Addendum #7

CONSIDER IN YOUR RESPONSE/BID THE FOLLOWING ITEMS OF ADDITION, DELETION OR CLARIFICATION. INDICATE IN THE SPACE PROVIDED ON THE RESPONSE/BID FORM THAT YOU HAVE RECEIVED AND INCLUDED FOR THE REQUIREMENTS OF THIS ADDENDUM. SICKKIDS MAY, IN ITS SOLE DISCRETION ANSWER SIMILAR QUESTIONS FROM VARIOUS RESPONDENTS ONLY ONCE.

RE: QUESTIONS AND ANSWERS, SPECIFICATIONS, DRAWINGS AND DOCUMENTS

**FINISH PLAN,
FURNITURE AND
EQUIPMENT PLAN**

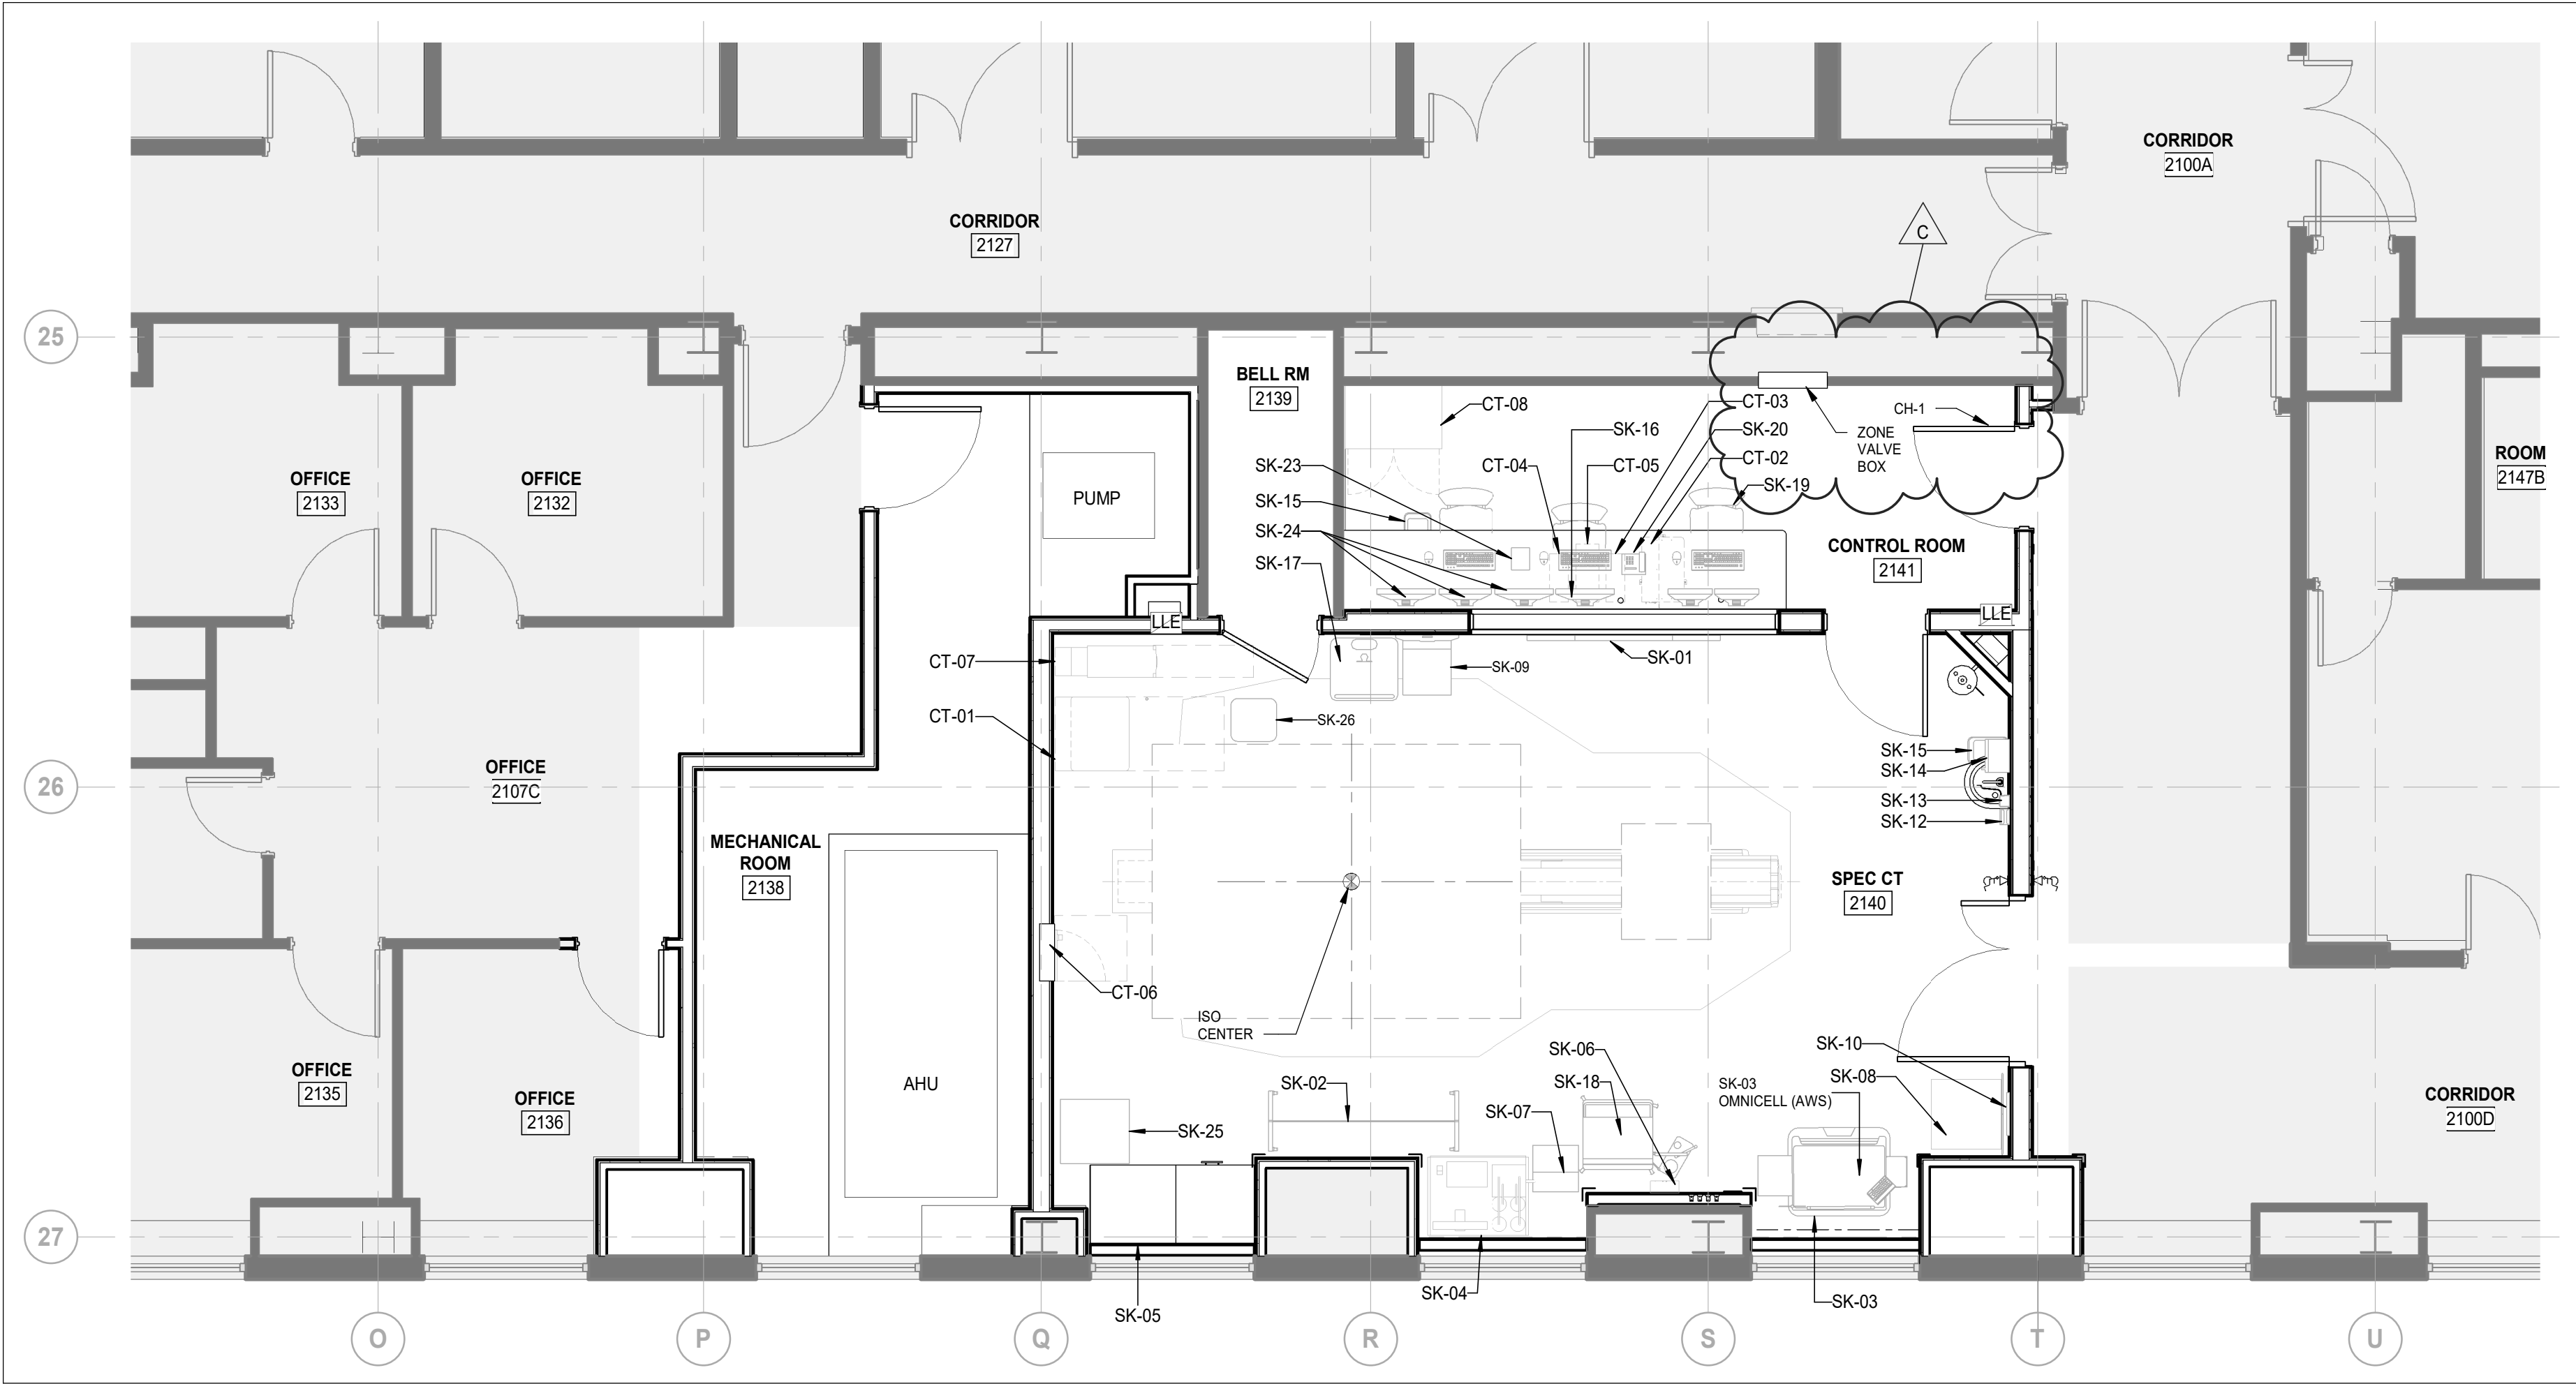
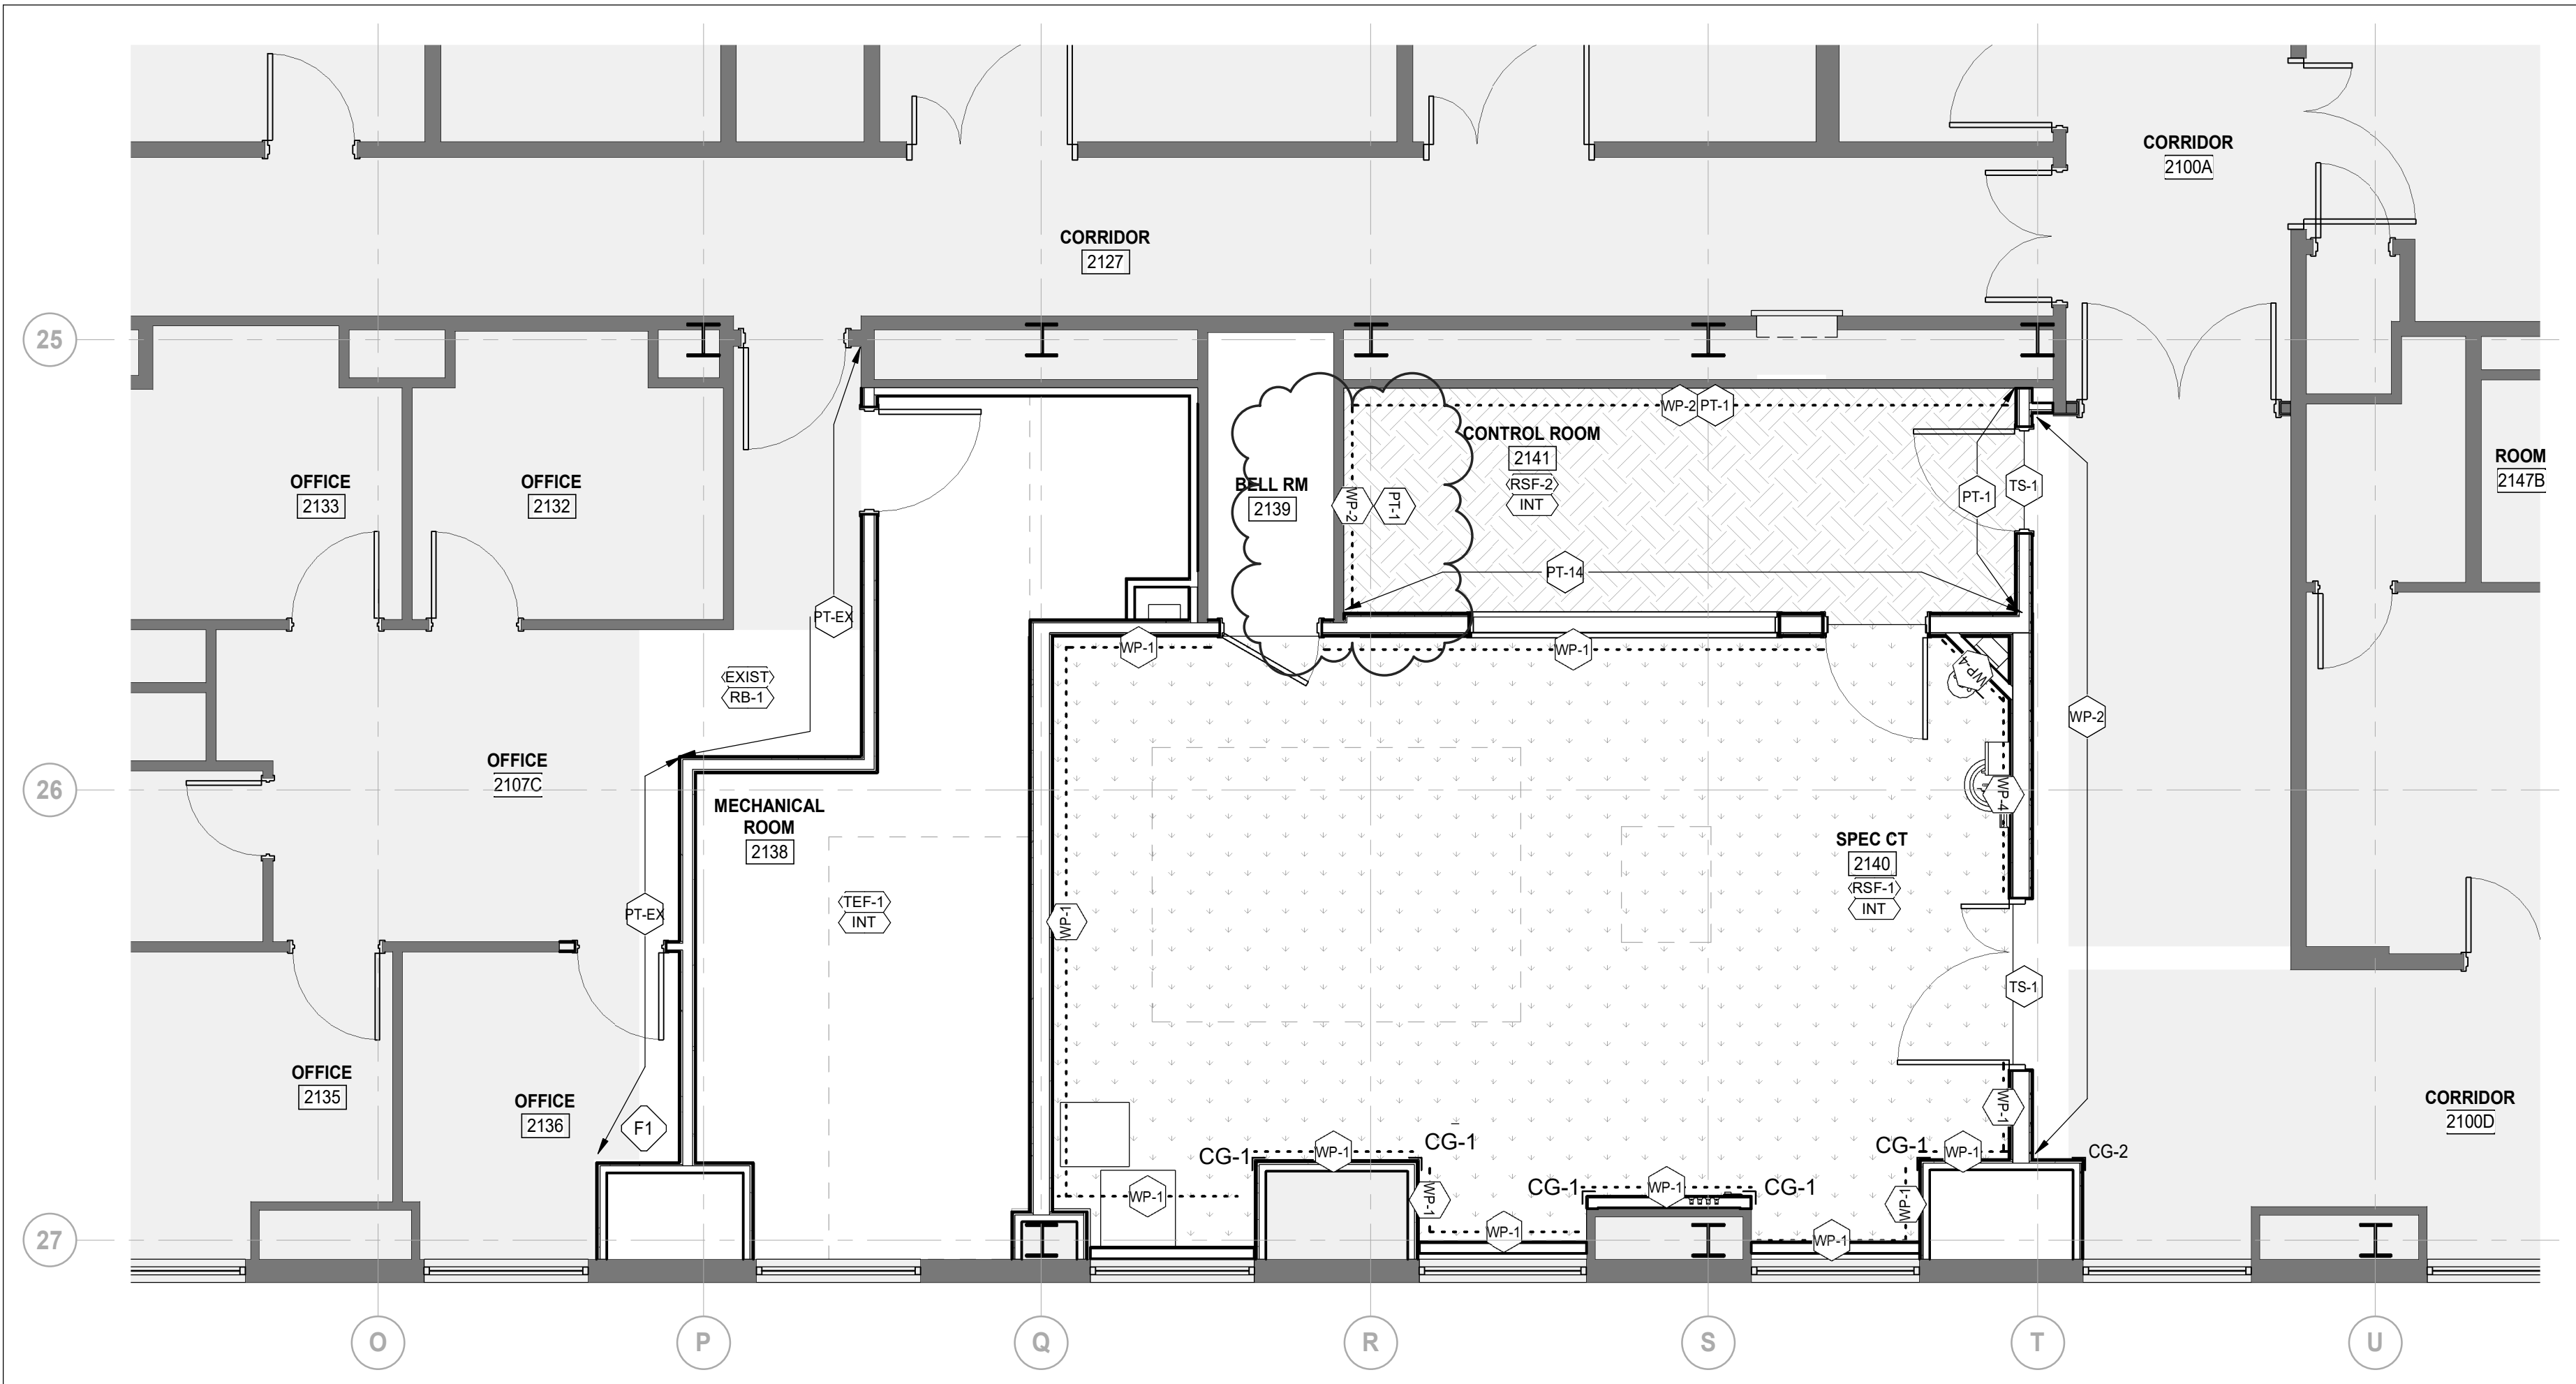
Q70-	How many coat hooks are required?	
	A70-	Please see equipment plan of this addendum for location Two are to be provided.
Q71-	A toilet paper holder (TPH) is specified, but should this be a paper towel holder? There is no toilet on this project.	
	A71-	there is no toilet paper holder. Clarification Paper Towel Holder is provided and installed by SickKids. Contractor to provide backing in location.

- .3 Drawing AB-02-BW-02 FINISH PLAN, FURNITURE AND EQUIPMENT PLAN
Added coat hooks location and med gases valve box
 - .4 Drawing AU-02-BW-01 ENLARGED SECTIONS
Removed Valve Box
